ADDENDUM No. 1

ECDC/ELN/286/022020

CONSTRUCTION OF MBODLA HERITAGE VILLAGE IN NGQUSHWA

QUESTIONS AND ANSWERS – 1

Drawing No. ARC-NDH-2-001 T1

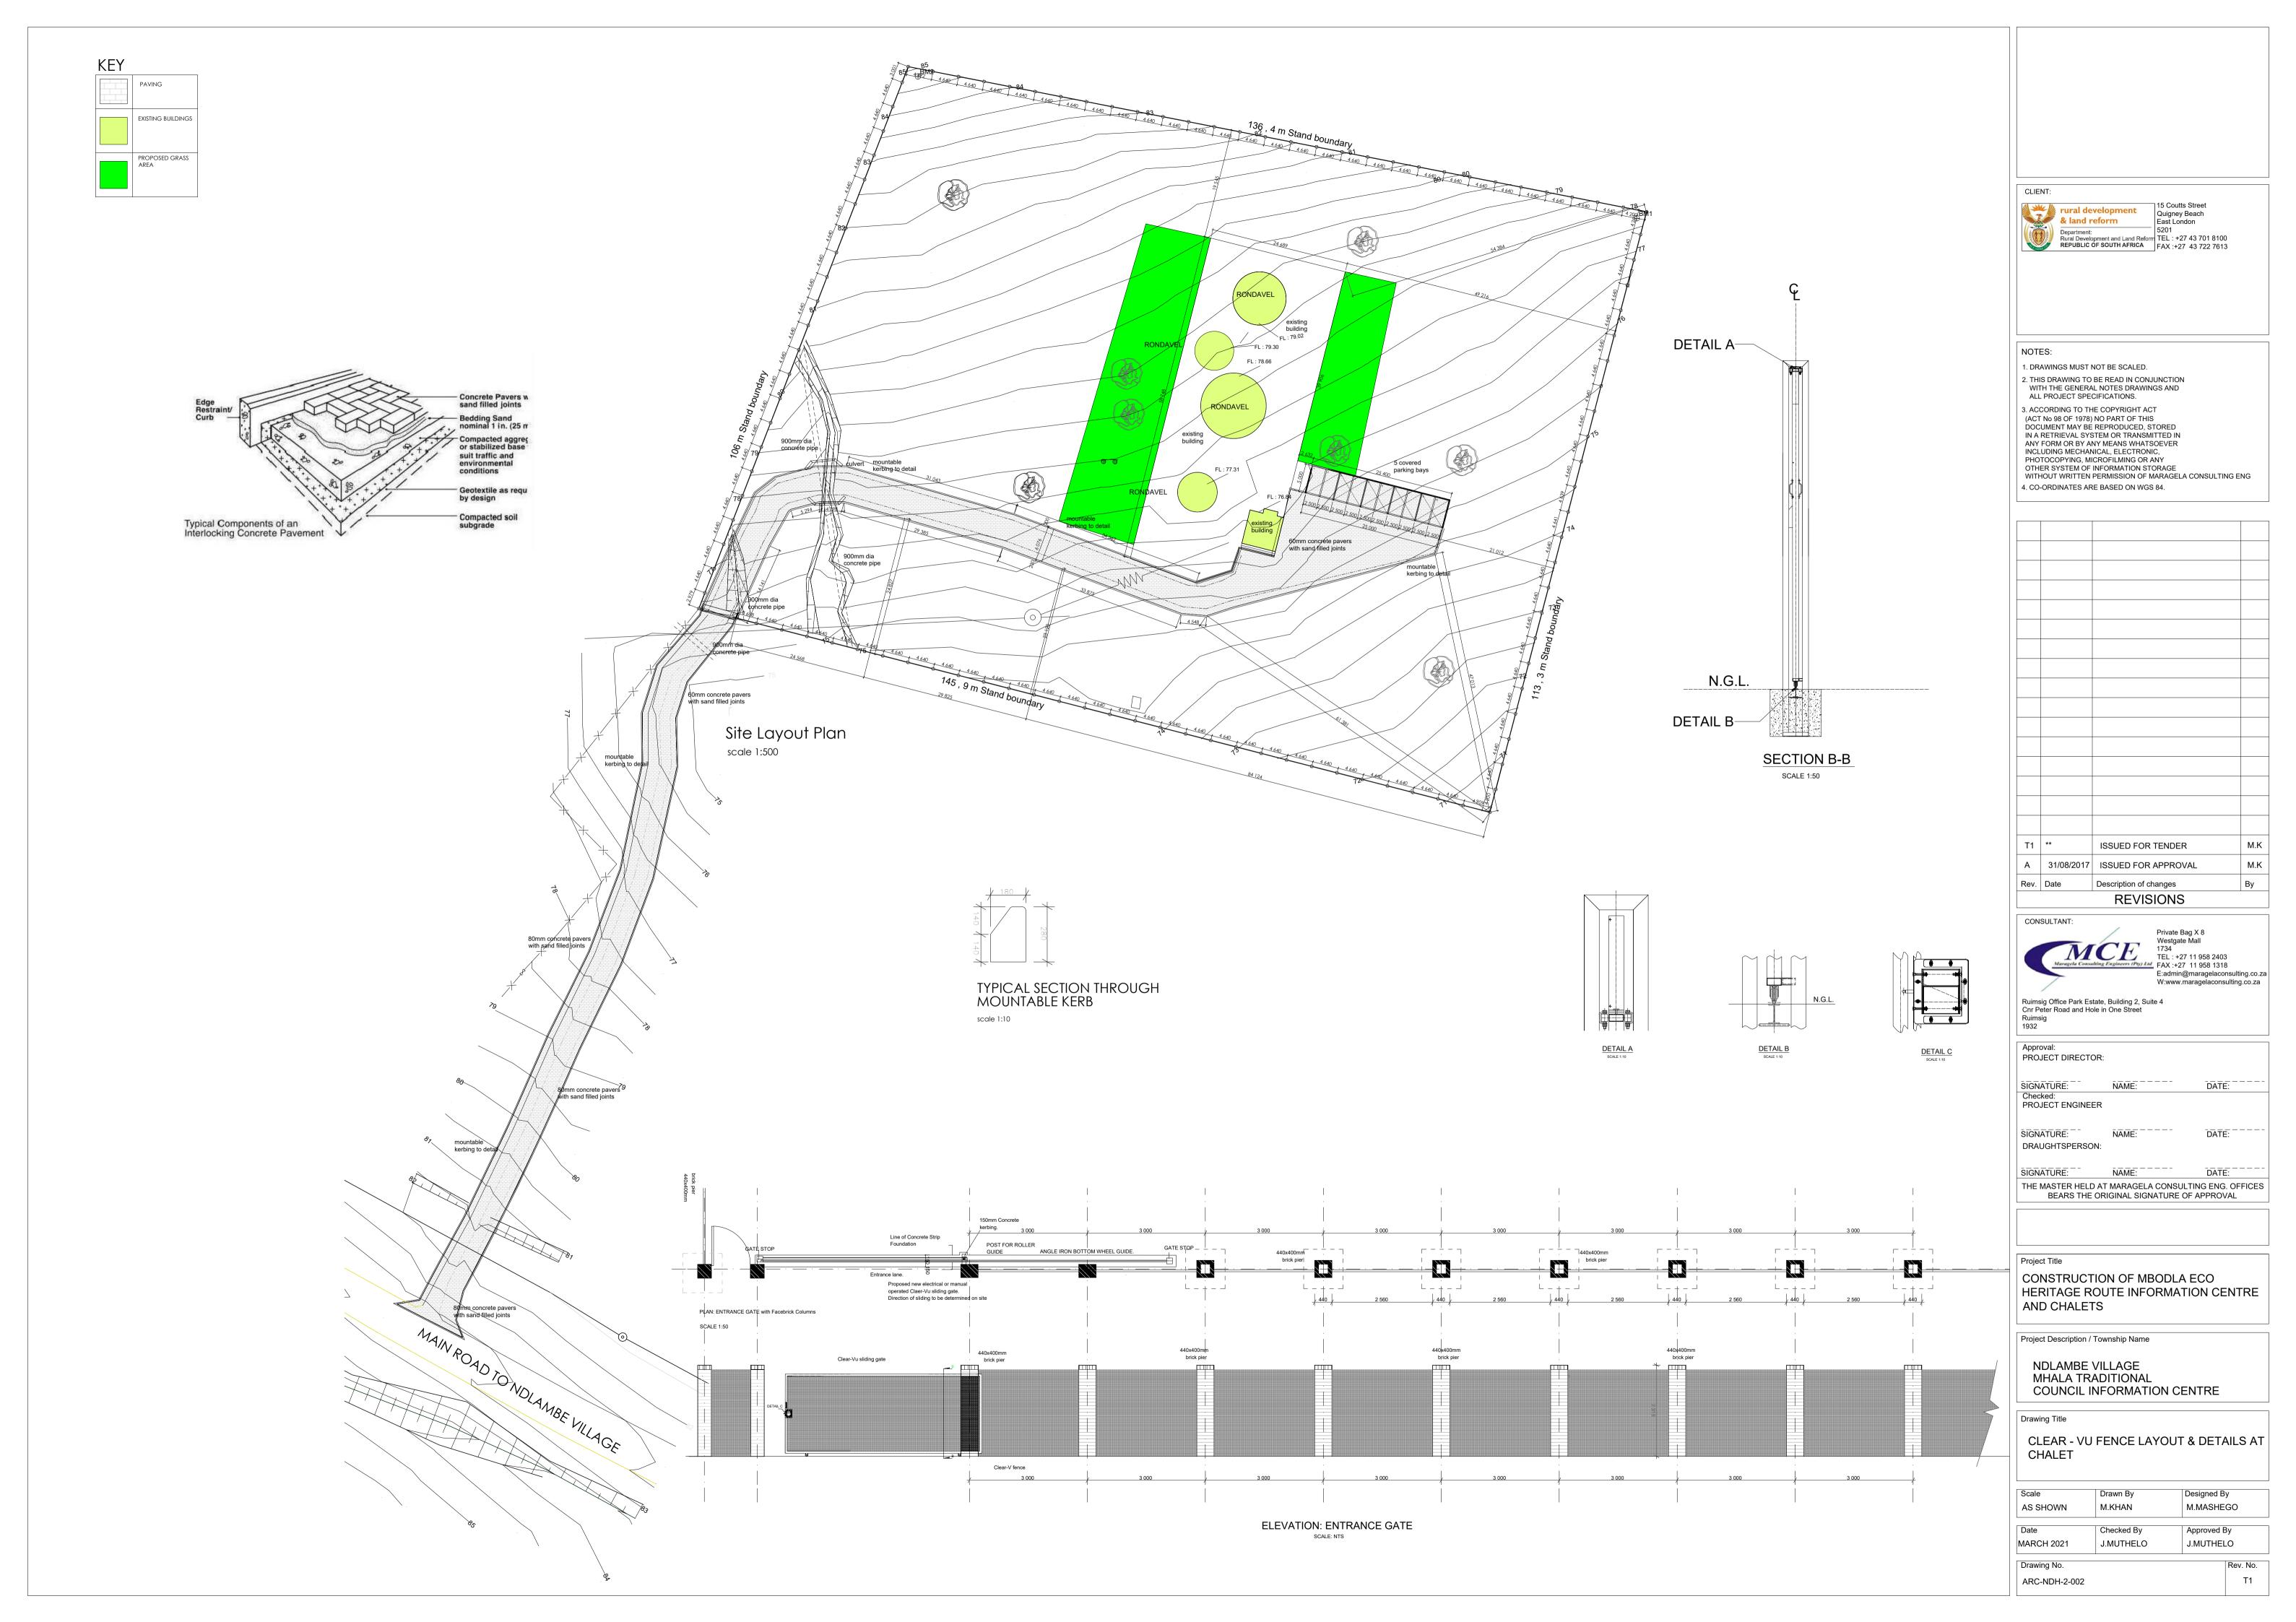
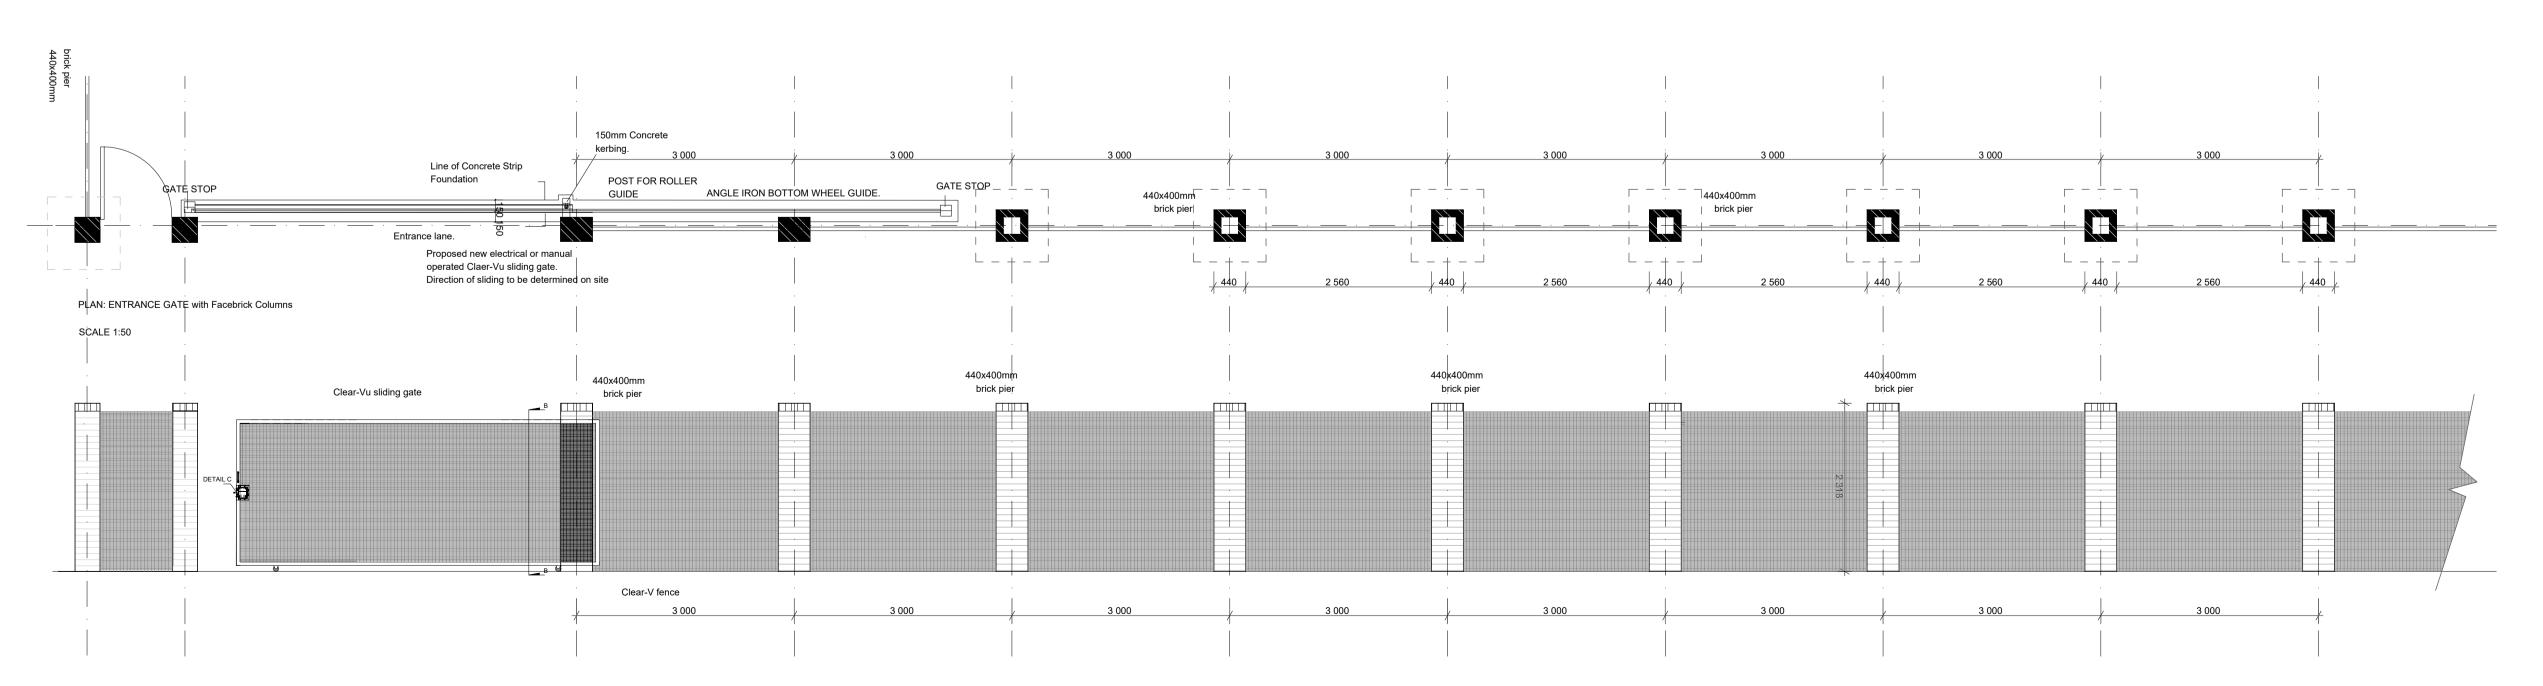
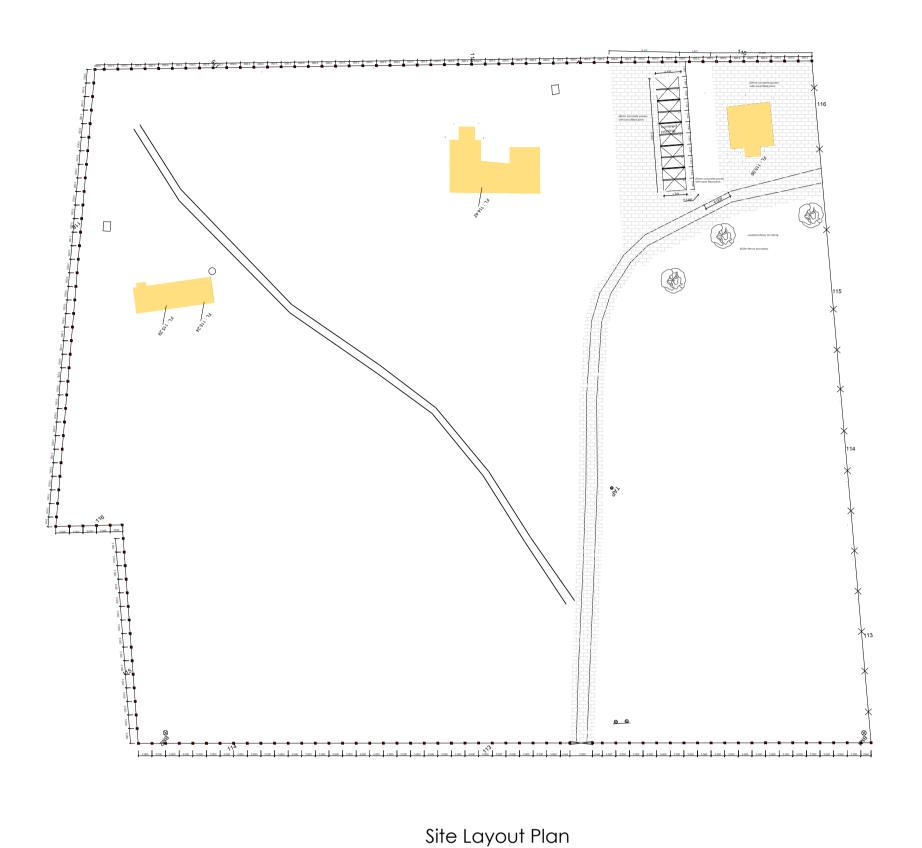
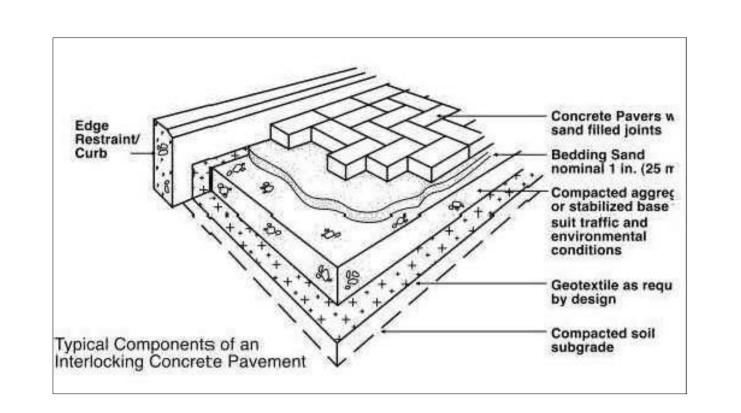
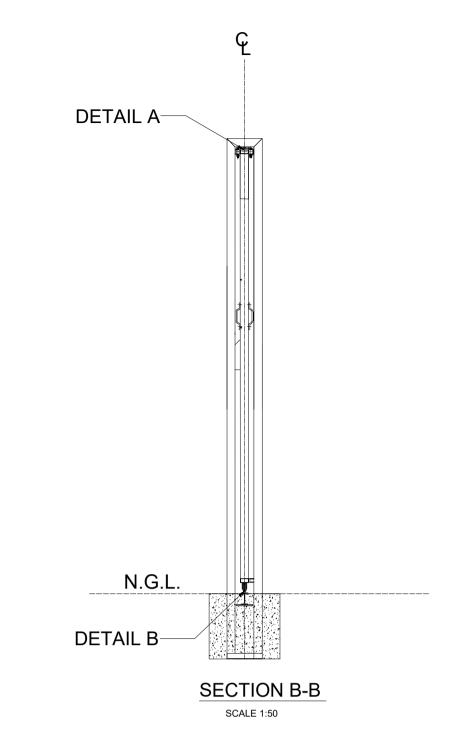
- Replace with drawing:
 ARC-NDH-2-001-T1 Clear-Vu fence layout & details at information centre
 ARC-NDH-2-002-T1 Clear-Vu fence layout & details at Chalets

2.	Can you please Clarify the following: • Fencing on the Information Centre has no Poles why?	Fencing on the Information Centre has no Poles why? There are existing piers that were constructed by the previous contractor. The contractor will only replace 5 damaged piers
